Nails Square – 201 E Plank Rd – On 9/12/2025 the City of Altoona received a land development plan proposing the remodel of a 1500 SF building into a nail salon. A total of six waivers is being requested. Your agenda packet includes the latest plans, narrative, technical review and BCPC review. A recommended resolution for approval has been included.

NAILS SQUARE 201 E PLANK RD

The City of Altoona has reviewed the subject land development. Please note that the City received your submittal before the adoption of the new SALDO & Zoning Ordinances and therefore was reviewed for compliance with the old ordinance. The following items were included and reviewed in this submission: land development plans, narrative/stormwater analysis, and waiver list. The developer shall address the following comments and proceed with final plan preparation.

The Blair County Planning Commission is in receipt of the Nails Square Remodel and Exterior Improvements, located at 201 East Plank Road in the City of Altoona for review under the provisions of the Pennsylvania Municipalities Planning Code and other relevant statutes. Attached, you will find additional comments and recommendations pertinent to the

C-4.01

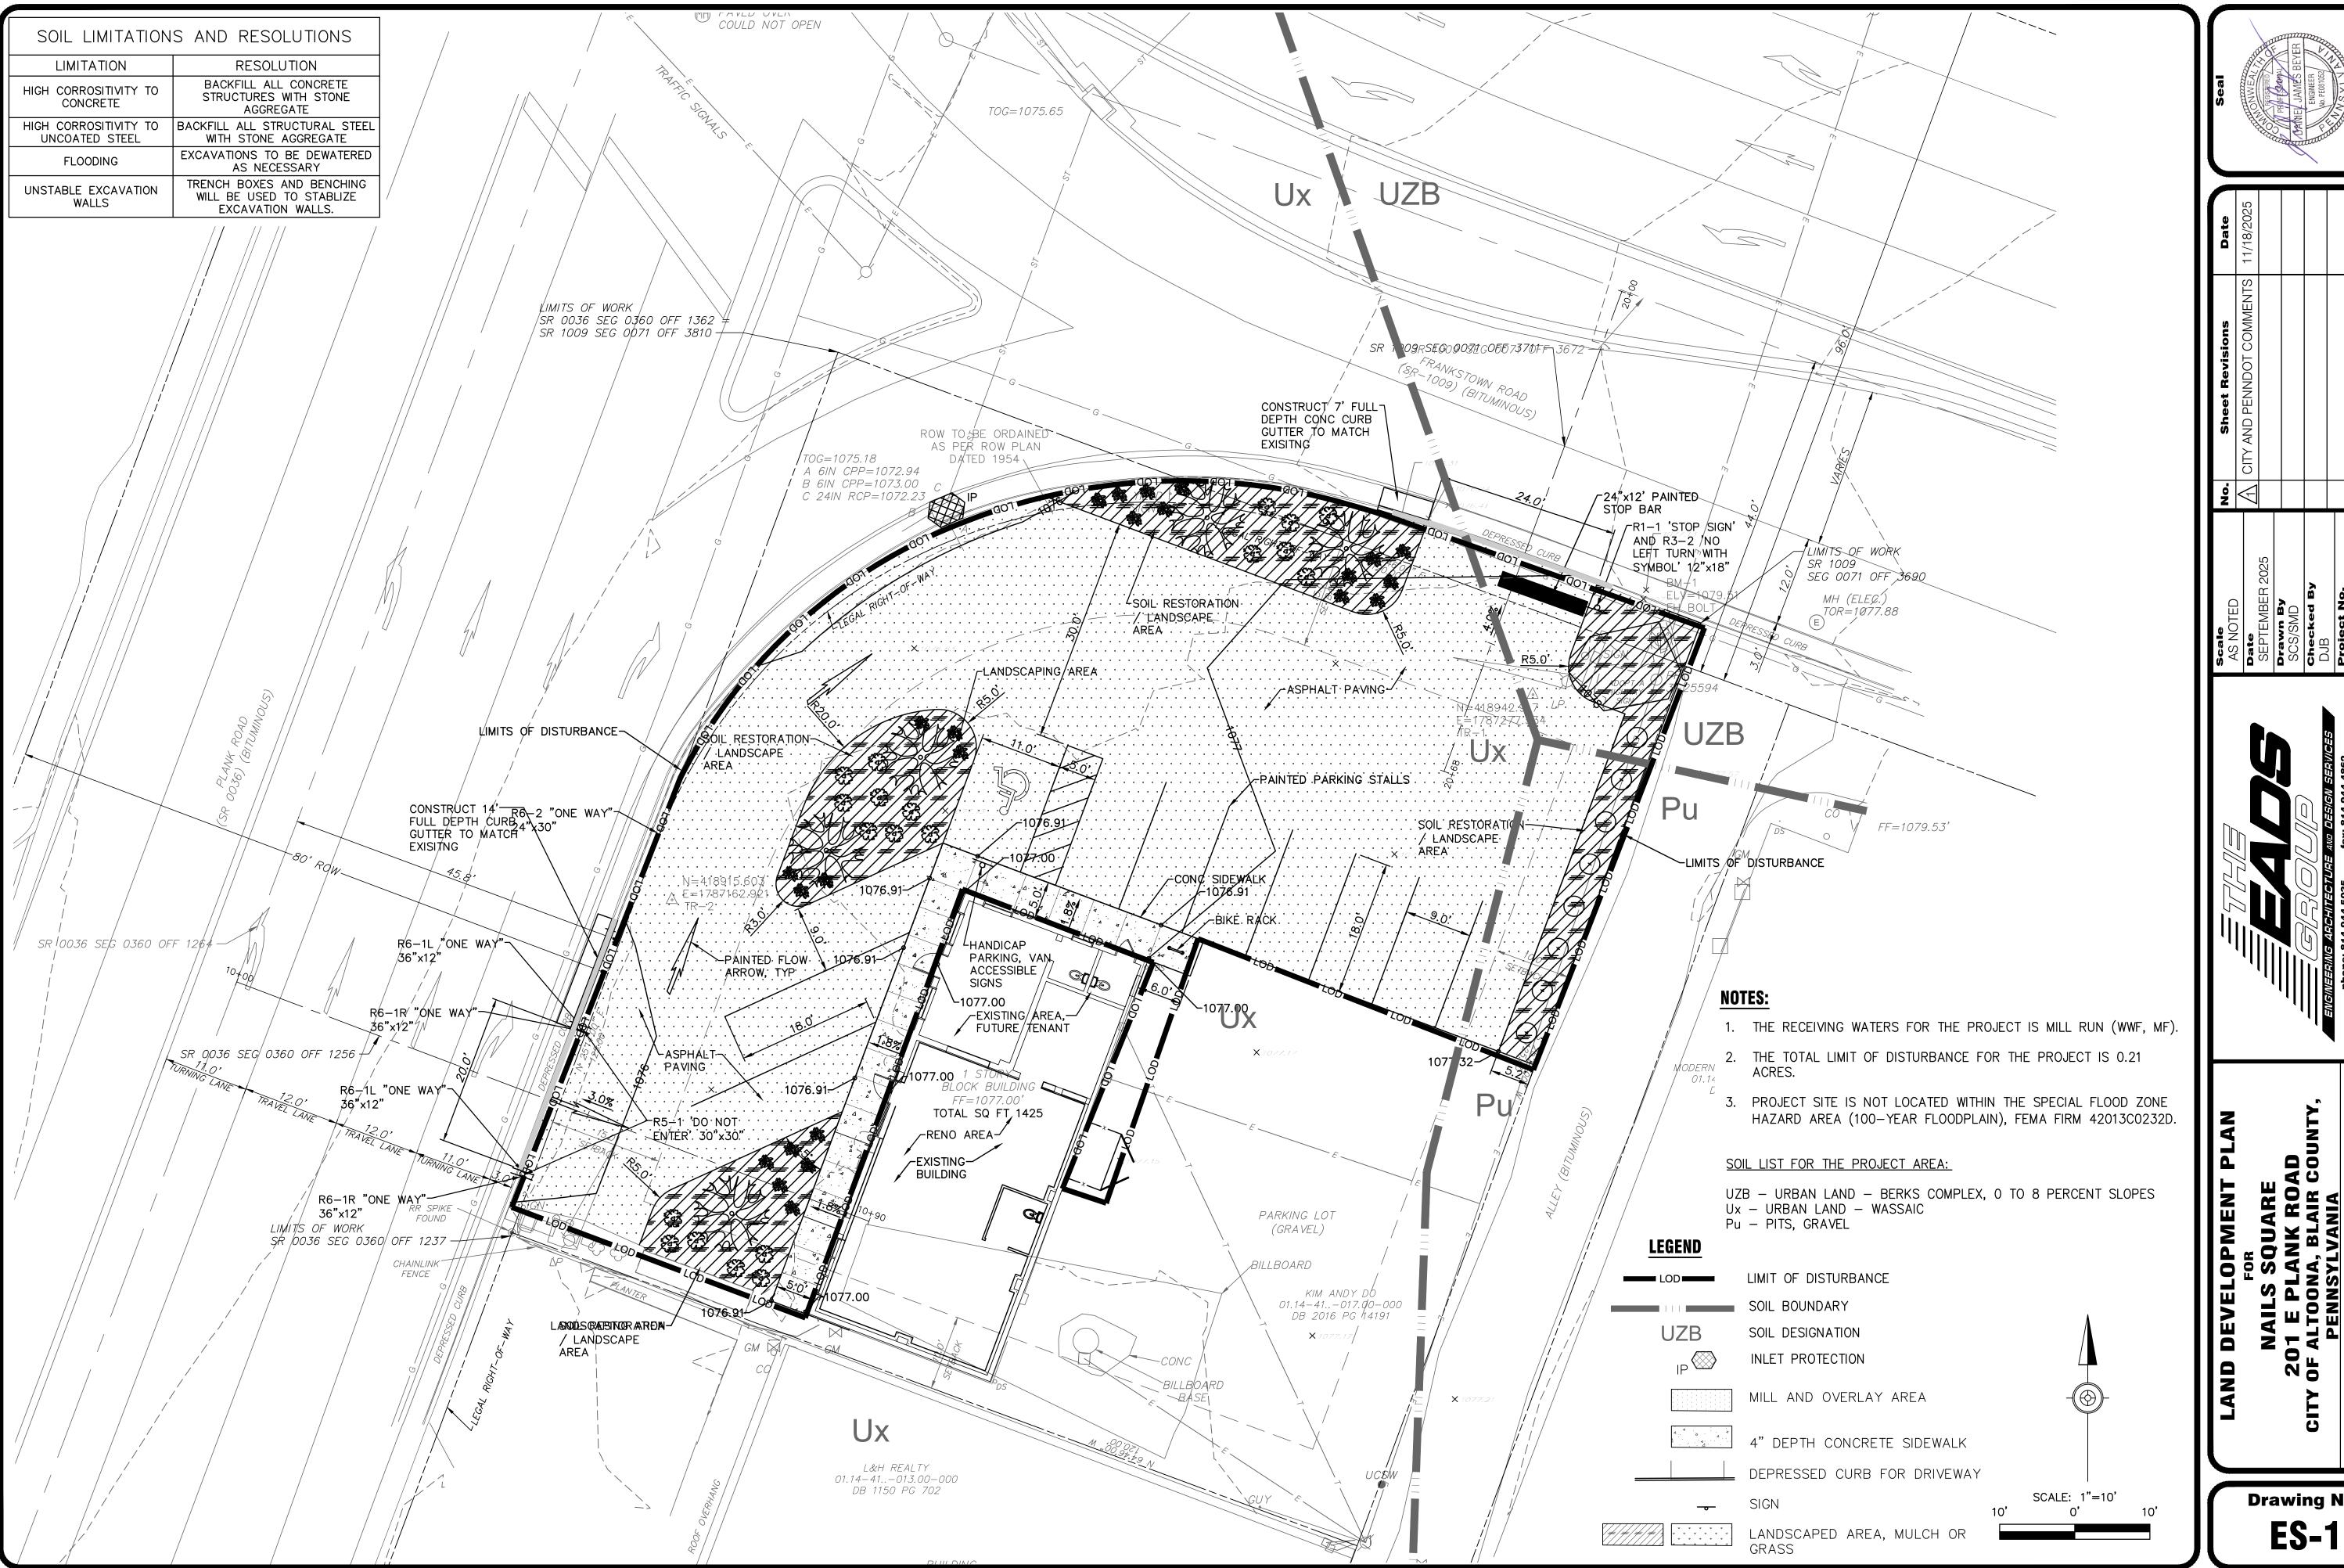
§640-63.G(1) "For every 10 spaces provided by the applicant for motor vehicles, one bicycle parking space shall be provided, with a minimum of two bicycle spaces for all proposals." Please provide a bike rack

NAILS SQUARE
201 E PLANK ROAD
CITY OF ALTOONA, BLAIR COUN
PENNSYLVANIA
EROSION AND SEDIMENTAT
CONTROL NOTES

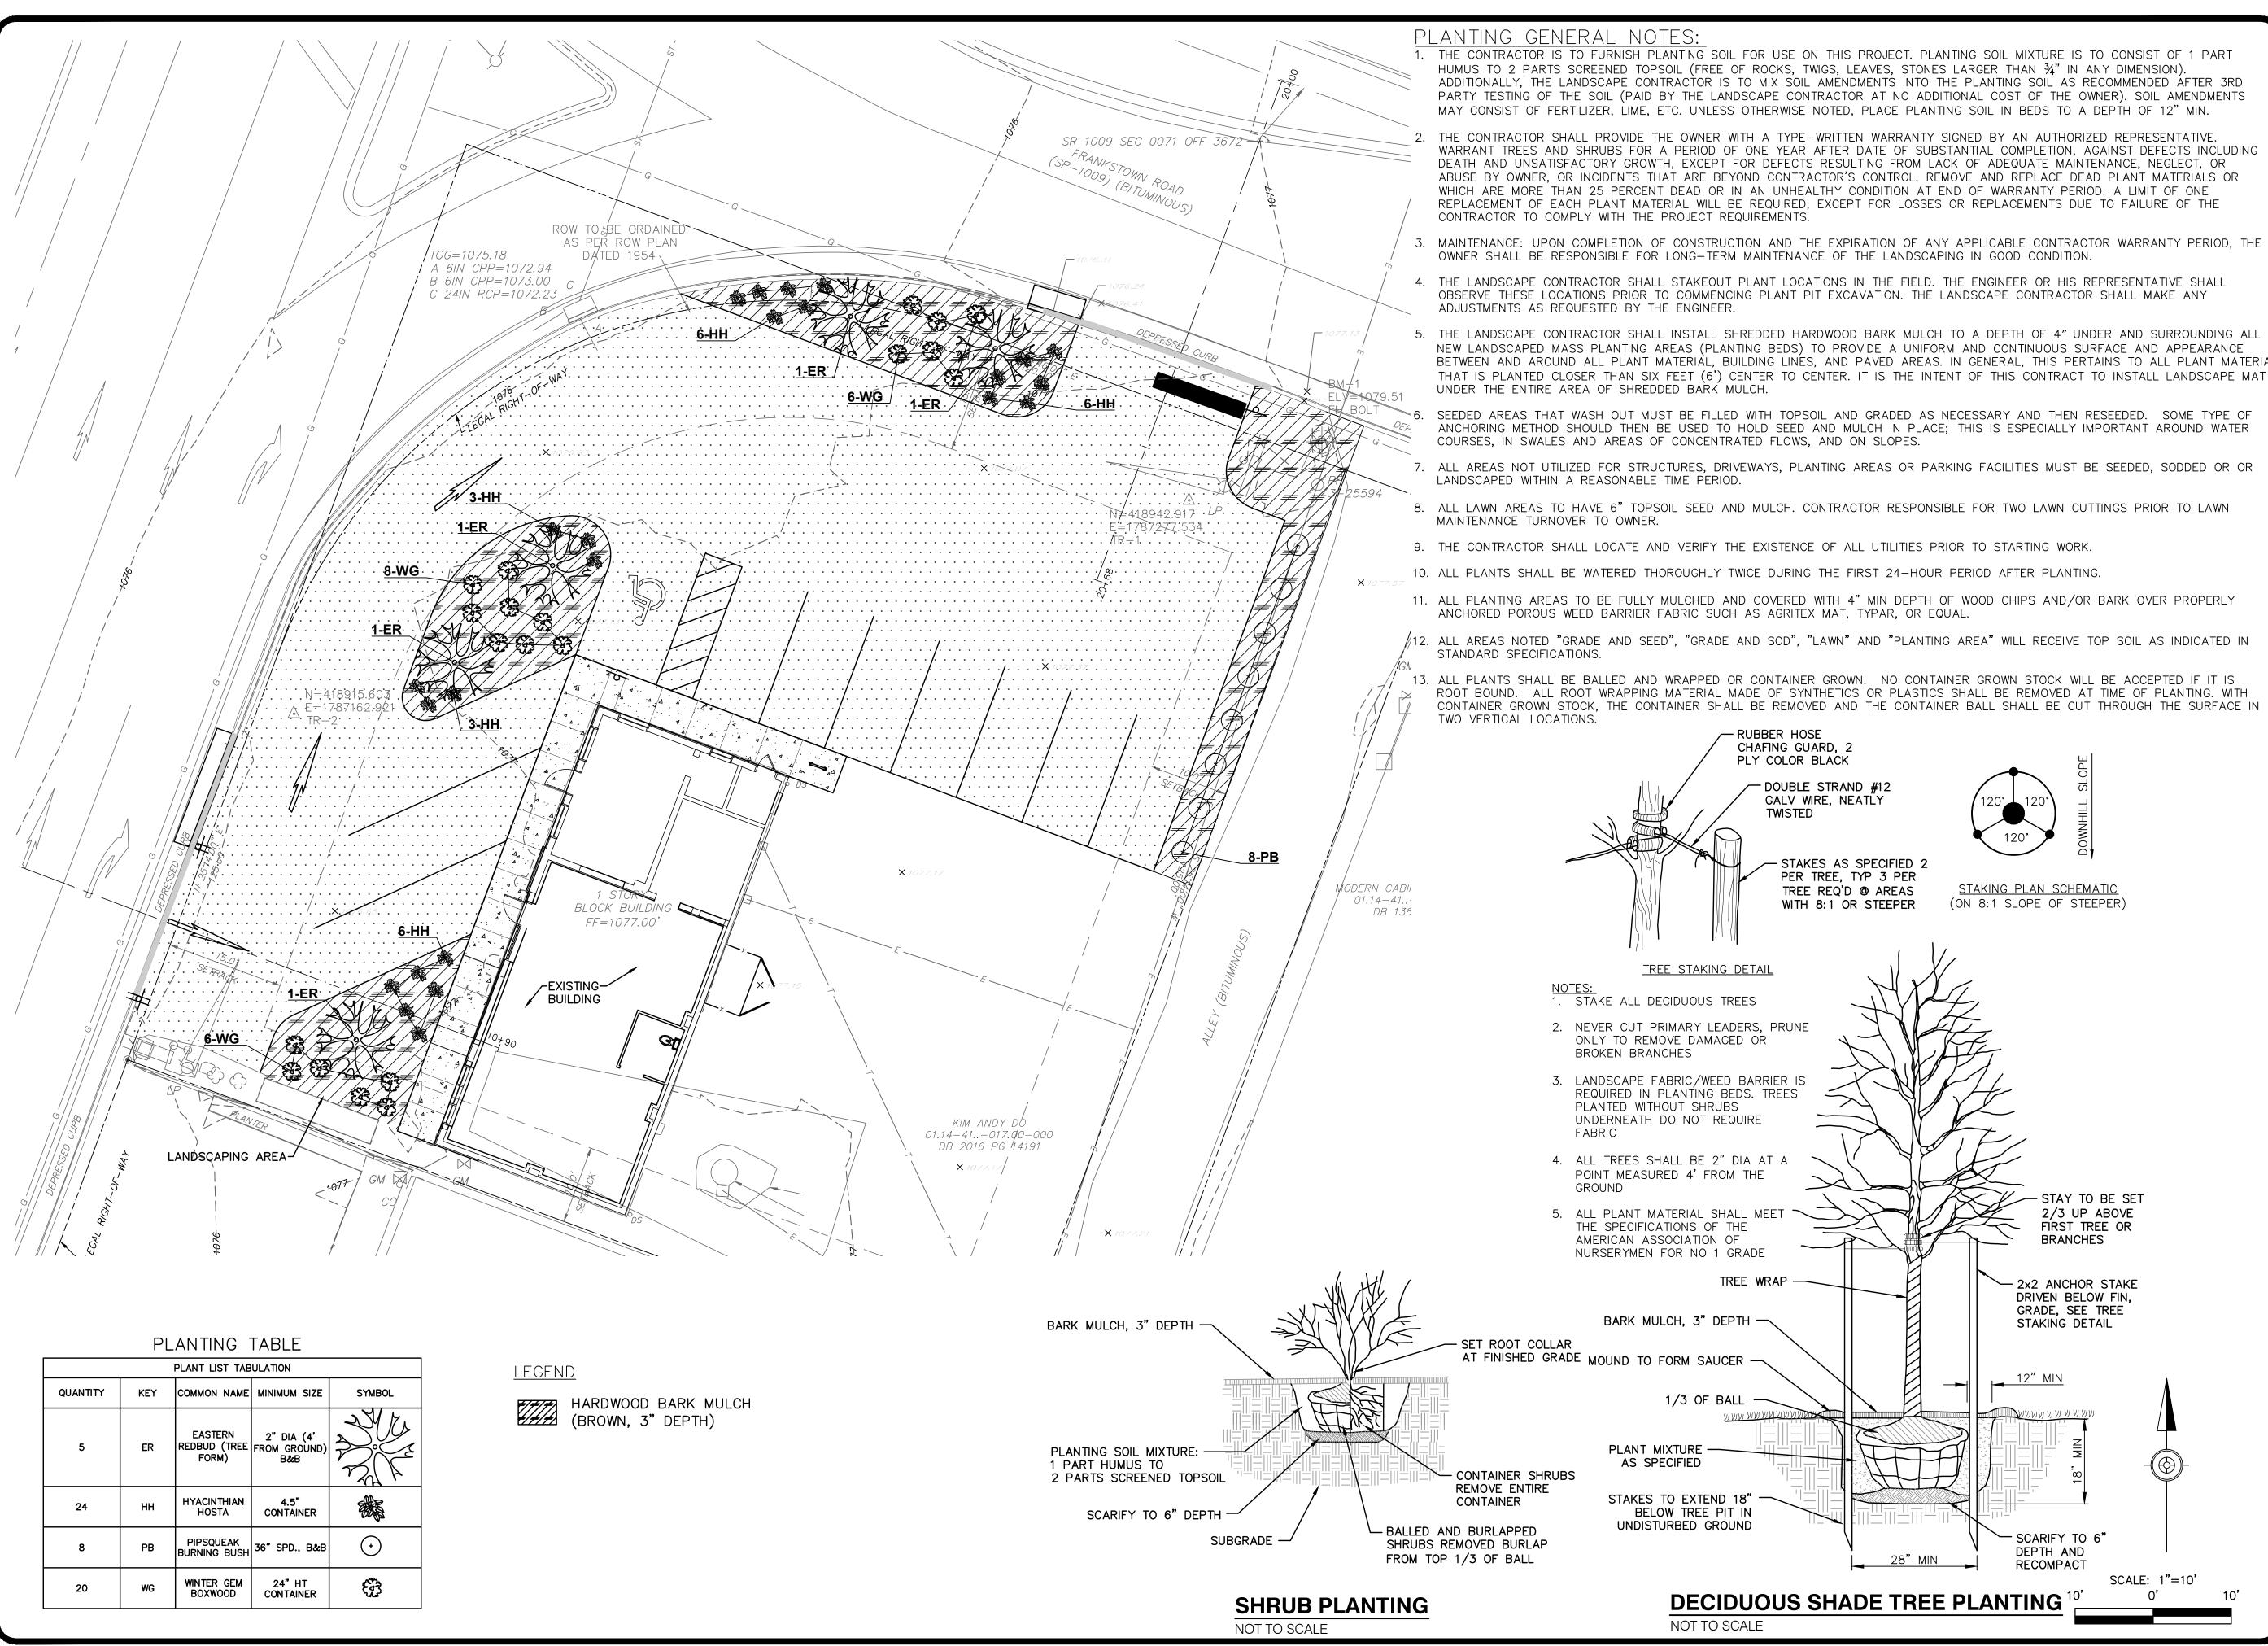
Please amend note 3 on sheet ES-1 "Project site is not located within the Special Flood Hazard Area (100-year floodplain), FEMA FIRM 42013C0232D."
